NUCLEAR ENERGY INSTITUTE

May 27, 2004

SUBJECT: *Federal Register* Notice 69 FR 11464, March 10, 2004, Workshop to Discuss Combined License Topic COL-10, 10 CFR Part 52, Subpart C, Emergency Planning Inspections, Tests, Analyses and Acceptance Criteria (ITAAC)

## Enclosure to NEI's May 27, 2004 Comments on EP ITAAC Workshop and EP ITAAC Proposals

**Figure 1: PART 52 PROCESS FOR EMERGENCY PLANNING**

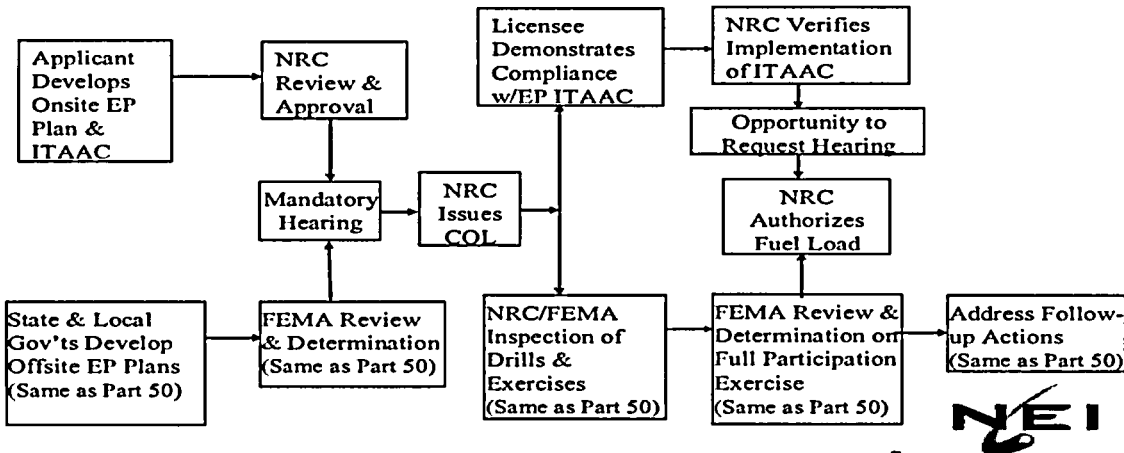
At the April 27 workshop, the industry presented Figure 1 to underscore certain key points. First, Figure 1 depicts that for plants licensed under Part 52; FEMA will review and make determinations on development and implementation of offsite emergency response plans by state and local organizations in the same way as it

has for plants licensed under Part 50. NRC will do likewise for the on-site EP elements by the licensee and will consider the offsite determinations by FEMA when making overall EP determinations required prior to COL issuance and prior to fuel load.

In addition to the normal inspections, evaluations and determinations by FEMA and the NRC, Part 52 licensees must also satisfy EP ITAAC established in the license, and the NRC staff must verify prior to fuel load that all ITAAC have been satisfactorily completed. As shown in Figure 1 and consistent with the principles outlined above, EP ITAAC should focus solely on significant on-site EP elements and offsite interfaces.

A second key point of the figure is that Part 52 provides for more timely and meaningful public consideration and participation in the licensing process regarding proposed emergency plans. Complete on-site and offsite emergency plans are developed by the licensee and state and local governments, respectively, and are subject to review in a mandatory hearing prior to license issuance. This is the public's principal opportunity to participate in decision-making concerning the

Figure 1 also highlights that FEMA will provide its determinations to NRC as it always has on the adequacy of offsite emergency plans (prior to COL issuance) and on the full participation exercise (prior to fuel load authorization).

Acceptance criteria for certain EP ITAAC will likely be shown to be met during conduct of drills and exercises, including the required full participation exercise. Figure 1 shows that results from NRC and FEMA inspections of drills and exercises may provide part of the basis for licensee ITAAC conclusions that EP ITAAC have been met. For example, FEMA may provide input regarding a test of the licensee's interfaces with offsite emergency responders.
